SHOWGROUND PRECINCT EAST

BUILDING A, B & C

SSD 62802207 MOD Proposed Facade Changes- Comparison Schedule

PROPOSED FACADE DEVELOPMENT

BUILDING C- ELEVATION COMPARISON

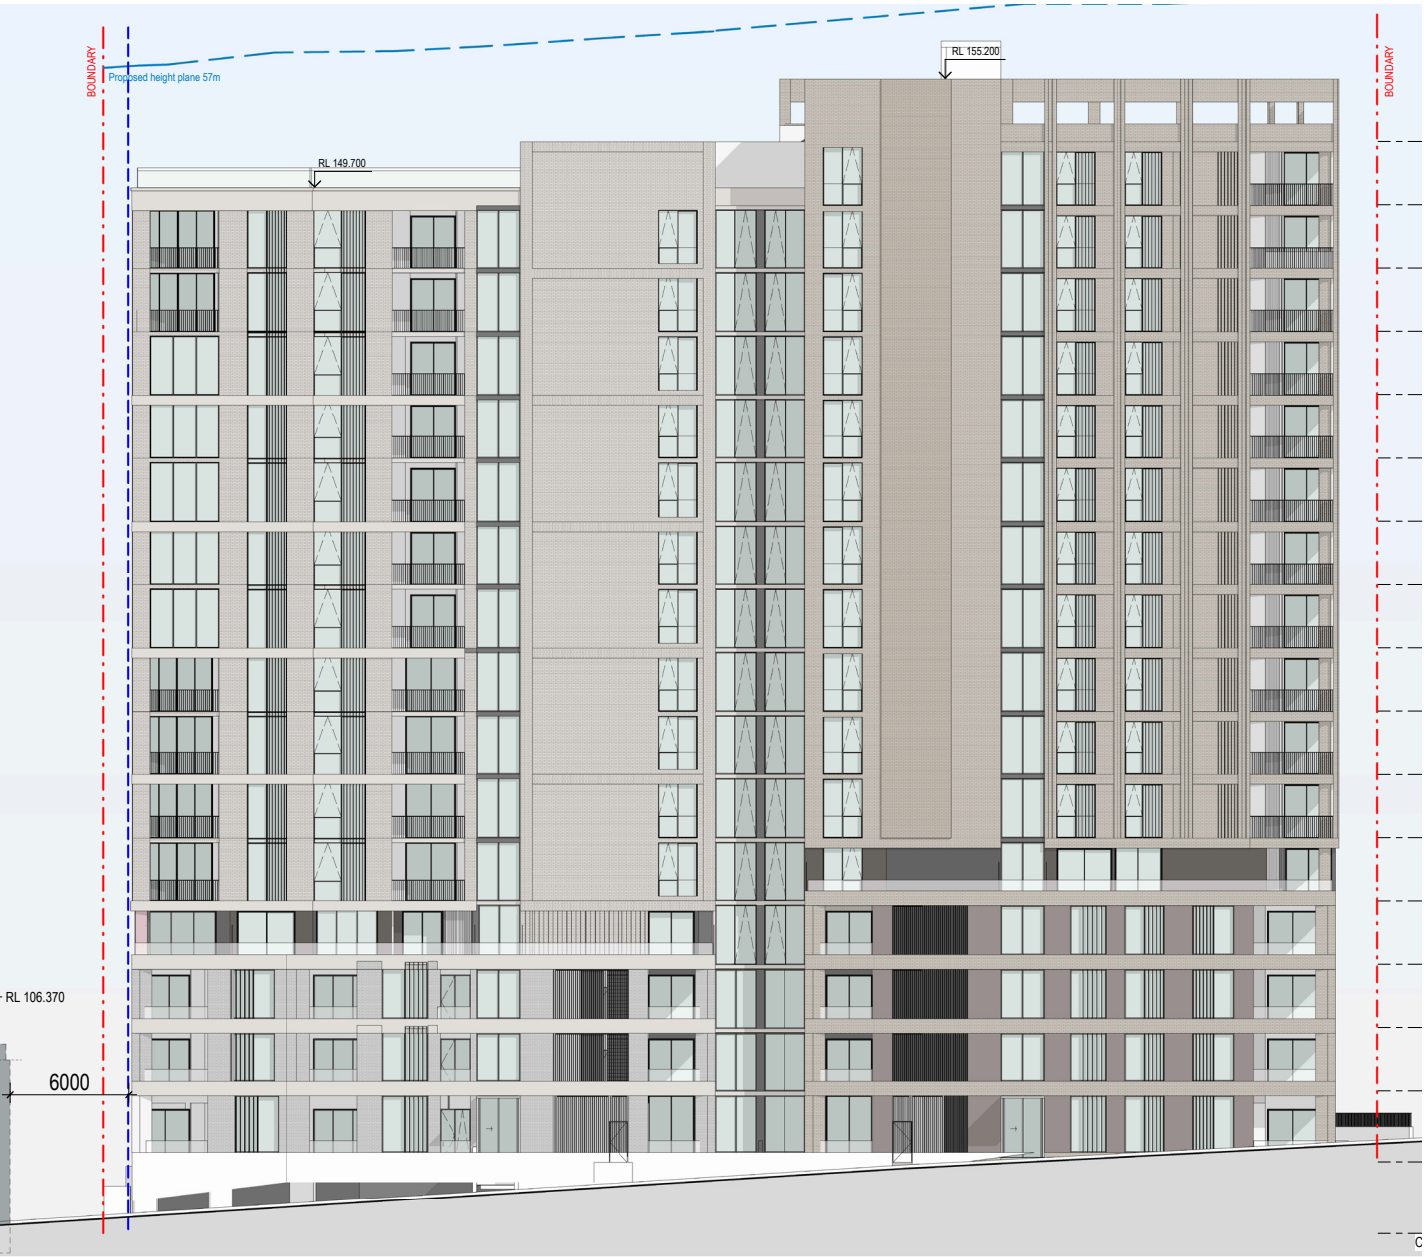
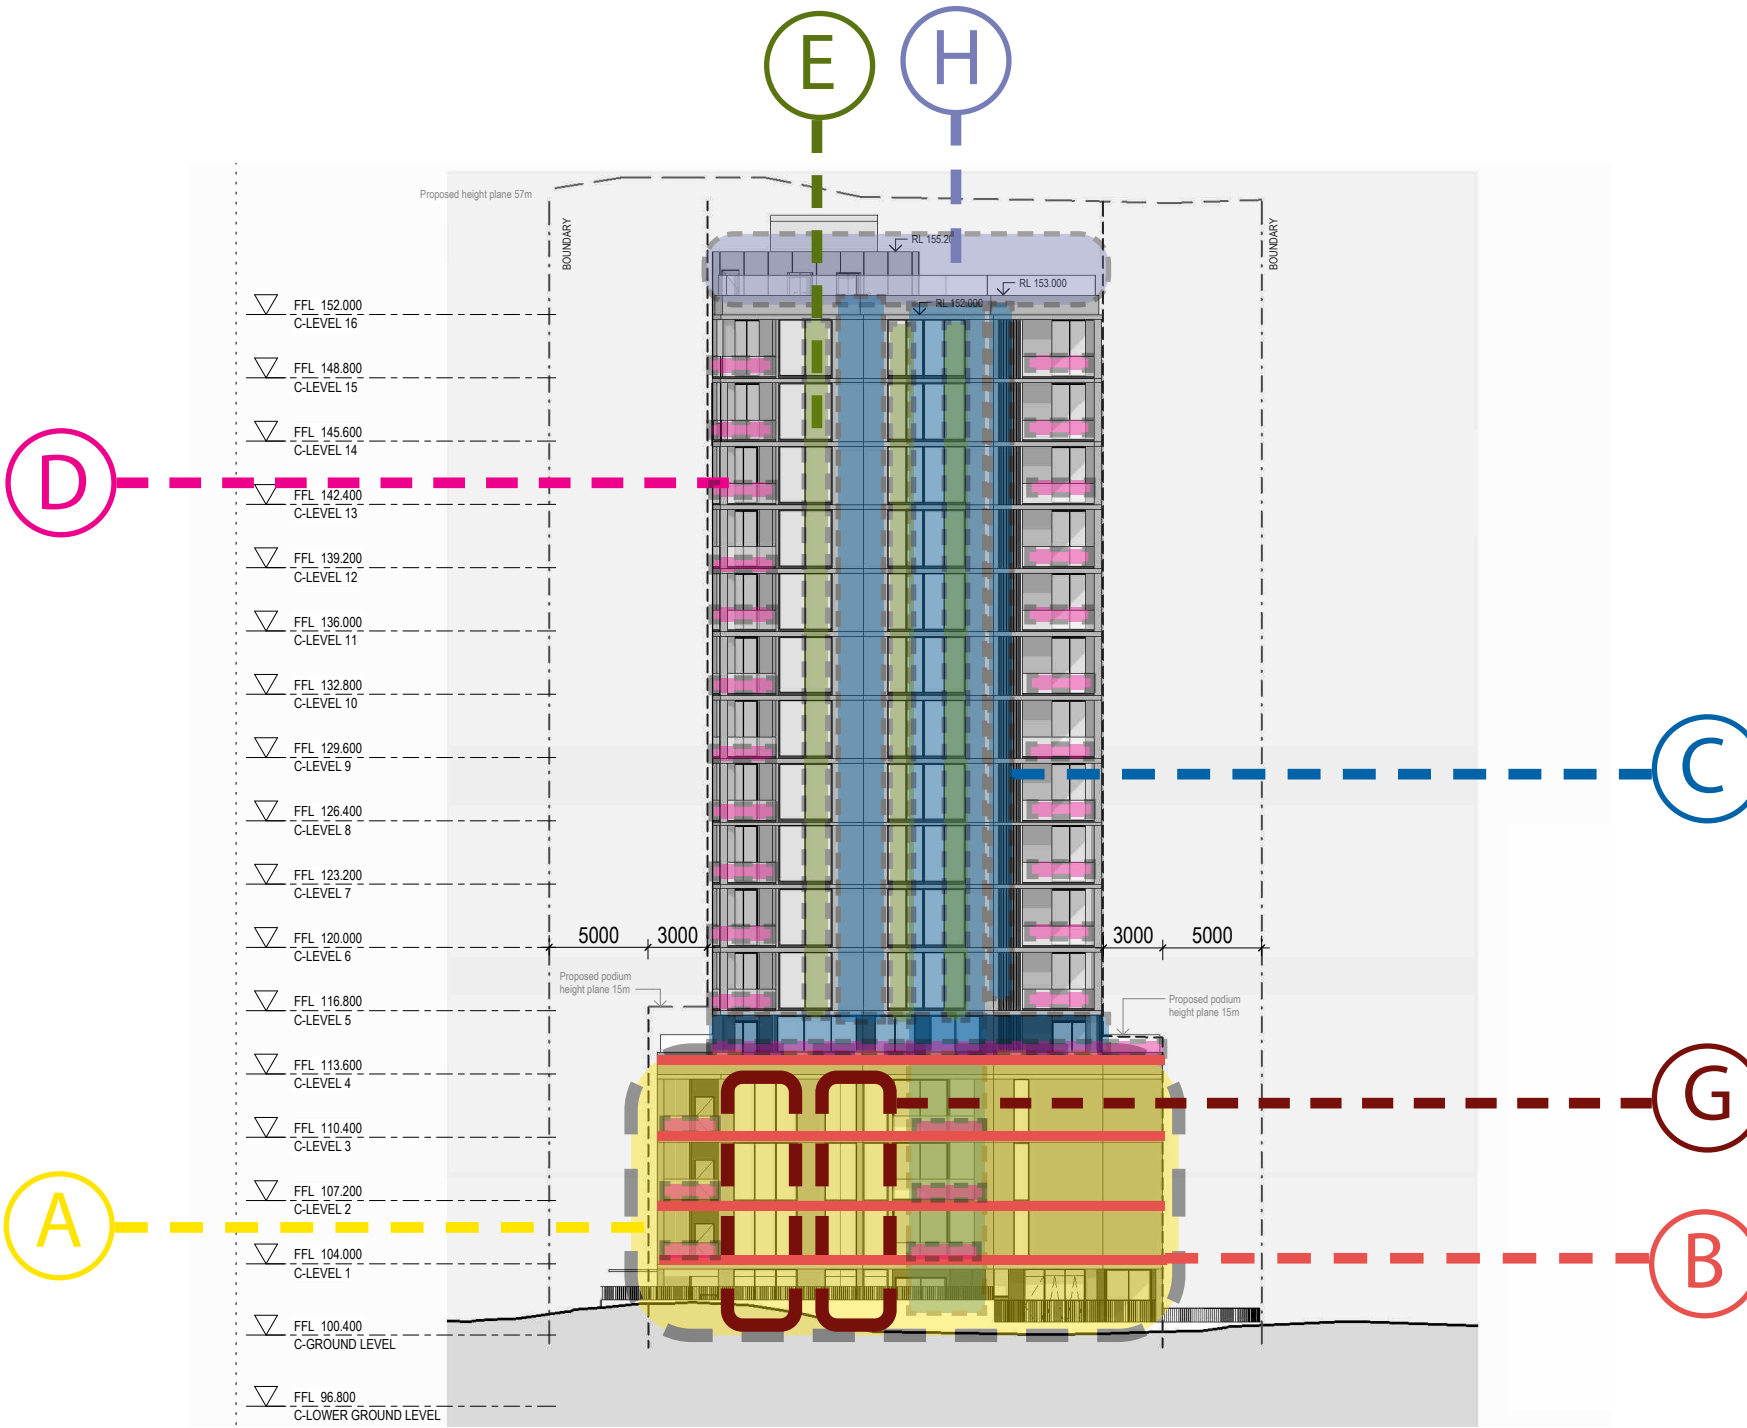
- A. Replaced applied tiles at podium levels with brickwork
- B. Exposed painted slab to podium level
- C. Replaced metal cladding/ brick panels to FC cladding to all tower facade
- D. Rationalised balustrades type to either full glass balustrade or full solid balustrade
- E. Adjustment to screens
- F. Lift and stair core walls changed to rendered and painted finish
- G. Upgrade windows at level 1-3 in Building C to full height glazing
- H. Remove roof frame
- N. Remove splay edges in Building A facade

SSD 62802207 Approved Facade Changes
South Elevation

Proposed Facade Changes:
South Elevation

BUILDING C- ELEVATION COMPARISON

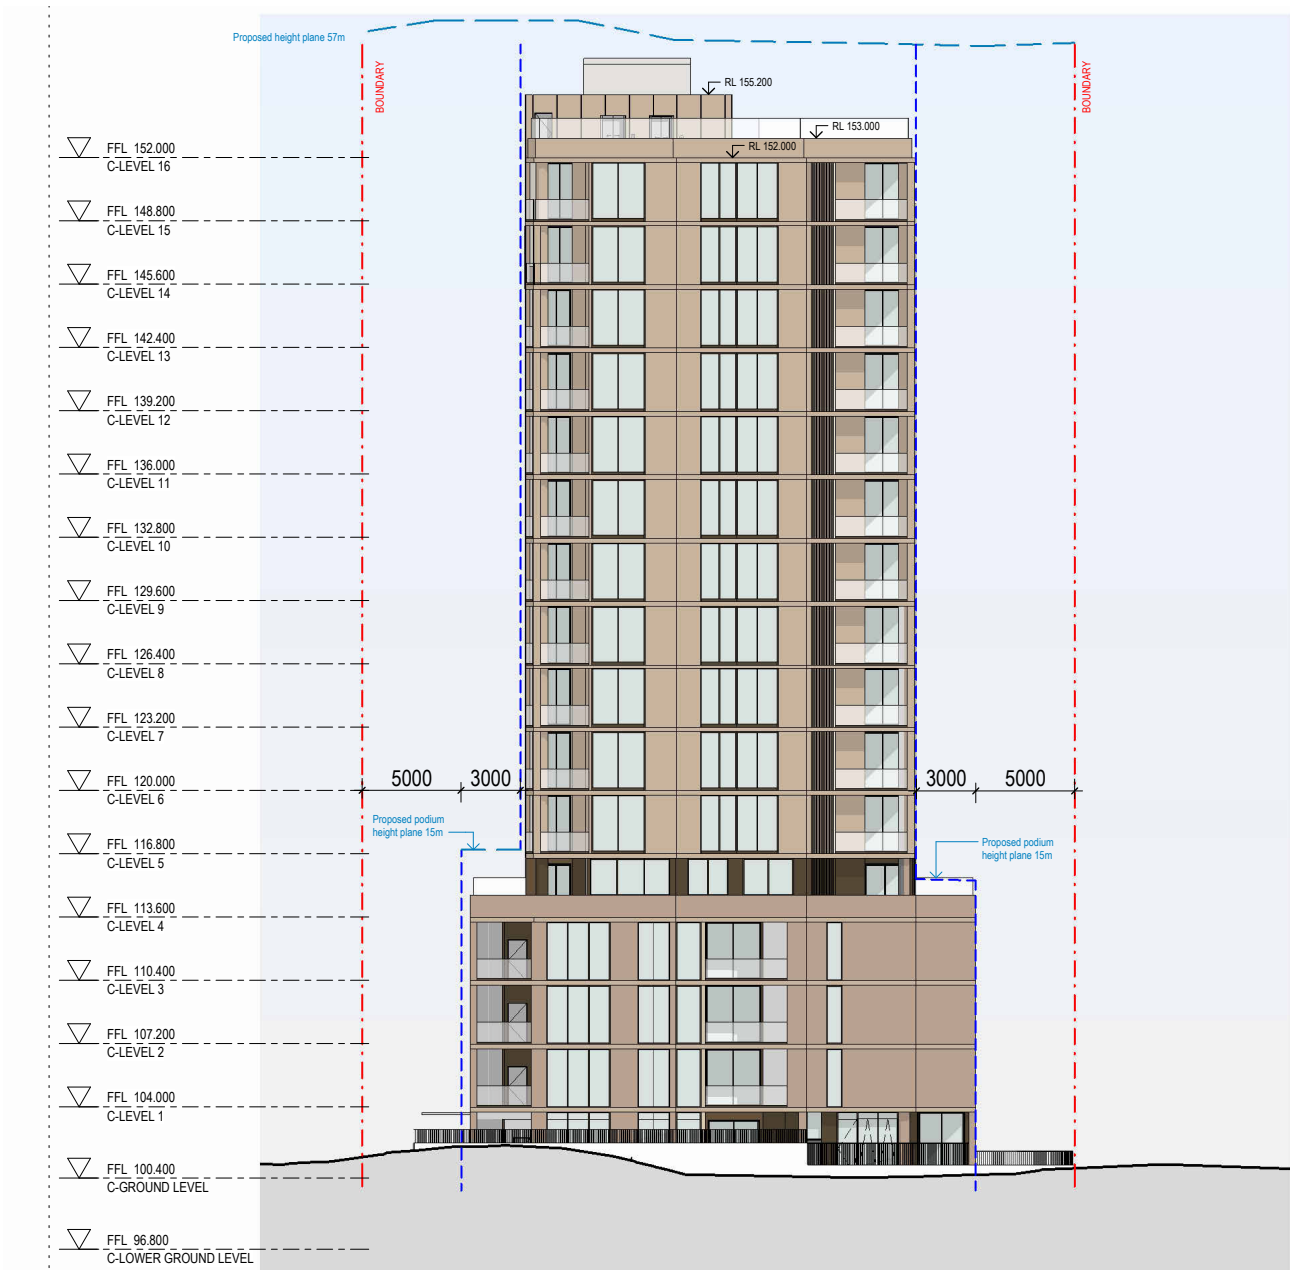
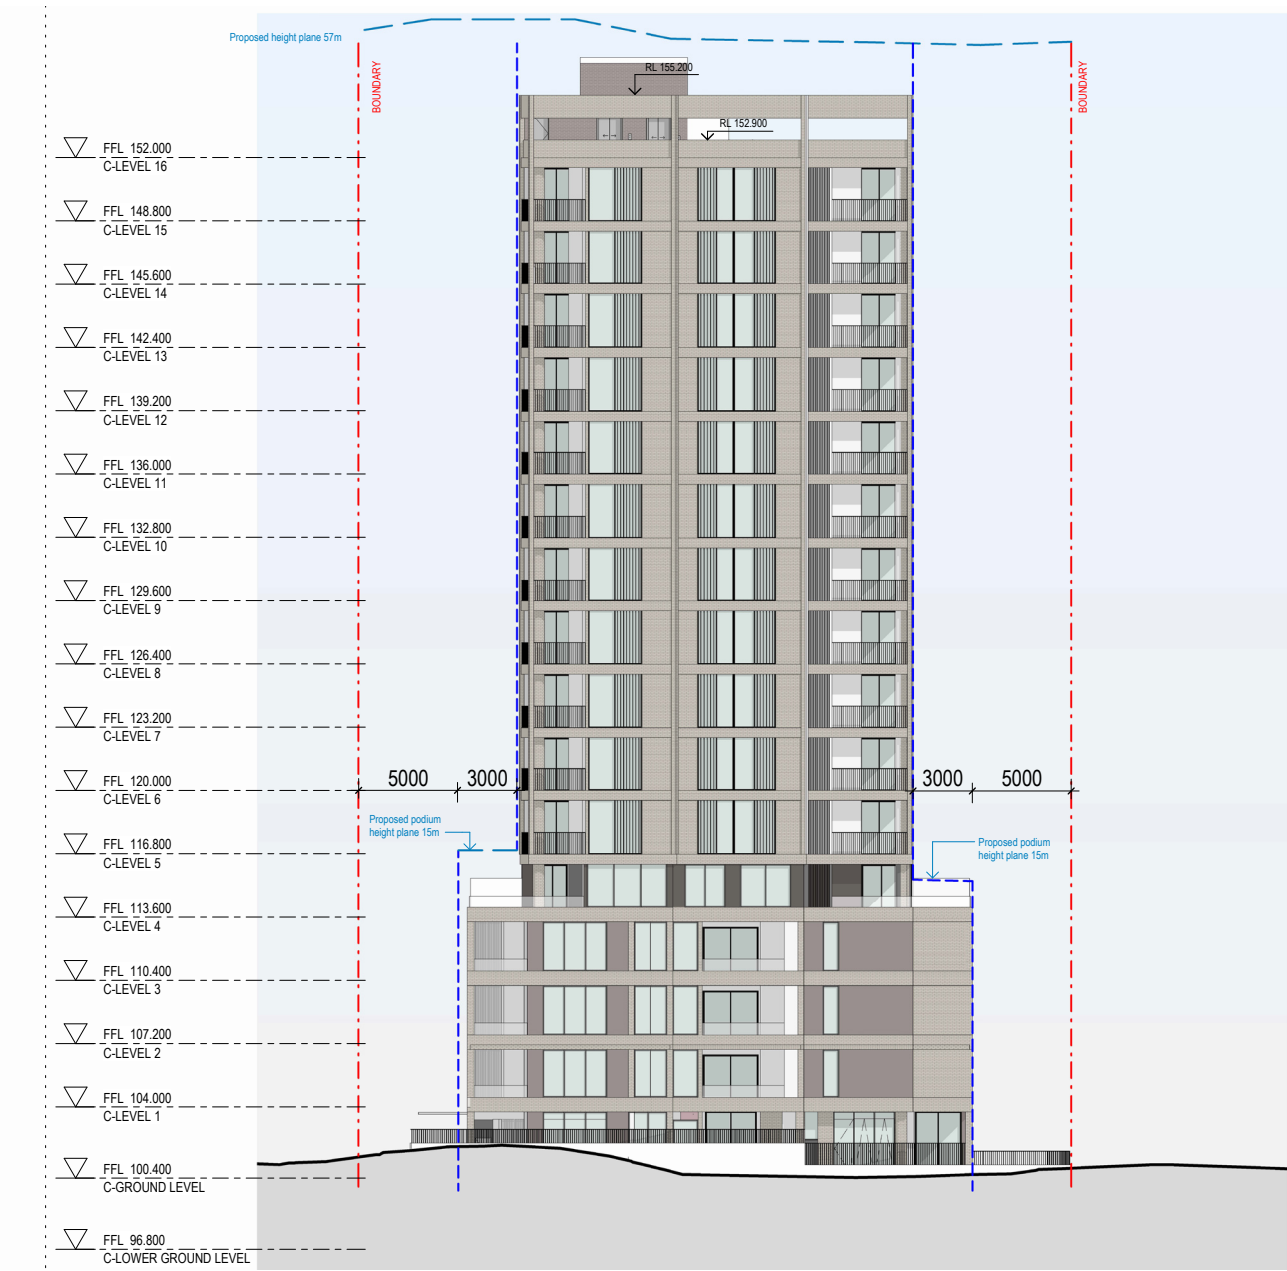
- A. Replaced applied tiles at podium levels with brickwork
- B. Exposed painted slab to podium level
- C. Replaced metal cladding/ brick panels to FC cladding to all tower facade
- D. Rationalised balustrades type to either full glass balustrade or full solid balustrade
- E. Adjustment to screens
- F. Lift and stair core walls changed to rendered and painted finish
- G. Upgrade windows at level 1-3 in Building C to full height glazing
- H. Remove roof frame
- N. Remove splay edges in Building A facade

SSD 62802207 Approved Facade Changes
East Elevation

Proposed Facade Changes:
East Elevation

BUILDING C- ELEVATION COMPARISON

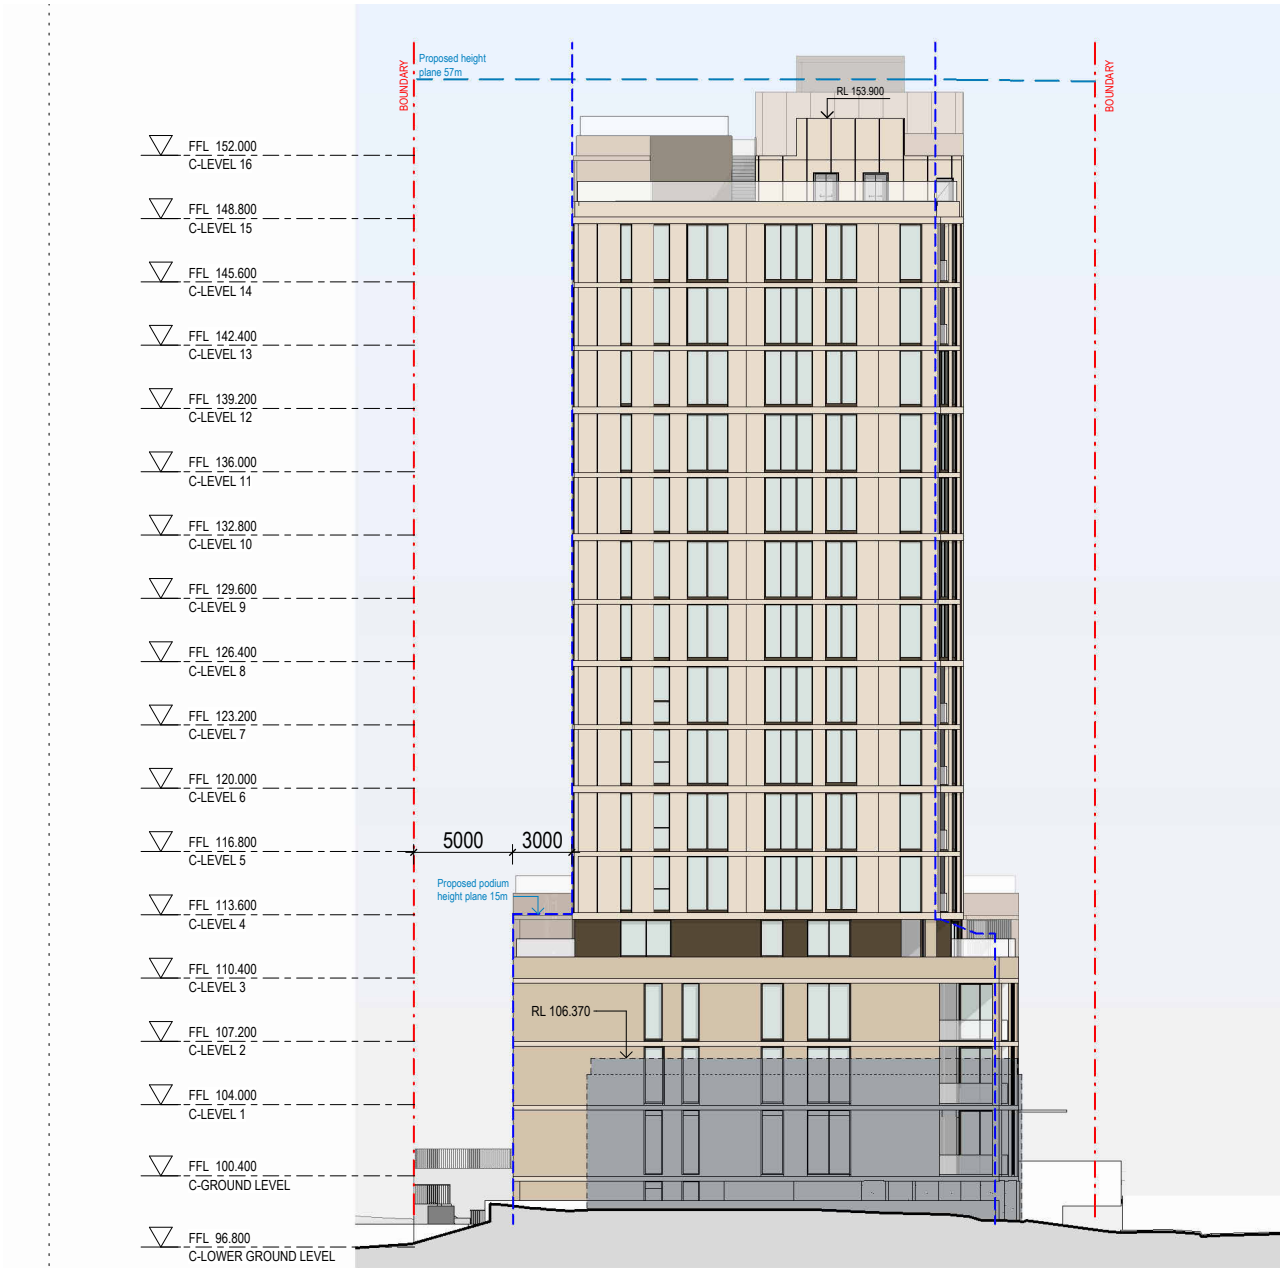
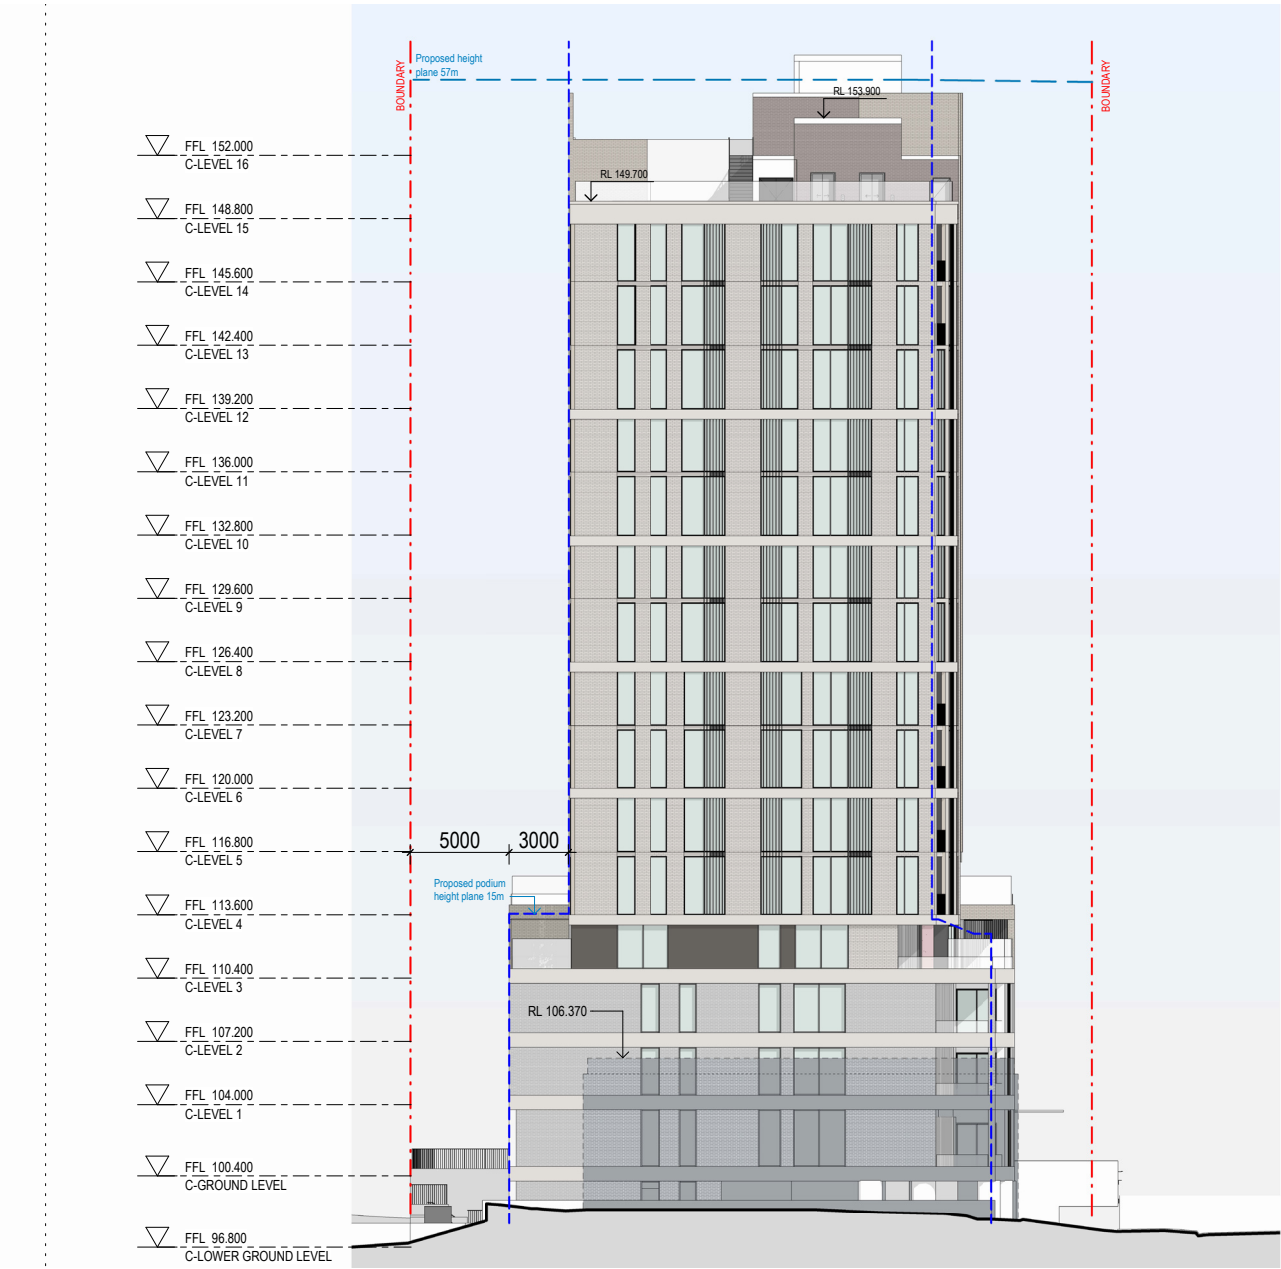
- A. Replaced applied tiles at podium levels with brickwork
- B. Exposed painted slab to podium level
- C. Replaced metal cladding/ brick panels to FC cladding to all tower facade
- D. Rationalised balustrades type to either full glass balustrade or full solid balustrade
- E. Adjustment to screens
- F. Lift and stair core walls changed to rendered and painted finish
- G. Upgrade windows at level 1-3 in Building C to full height glazing
- H. Remove roof frame
- N. Remove splay edges in Building A facade

SSD 62802207 Approved Facade Changes
West Elevation

Proposed Facade Changes:
West Elevation
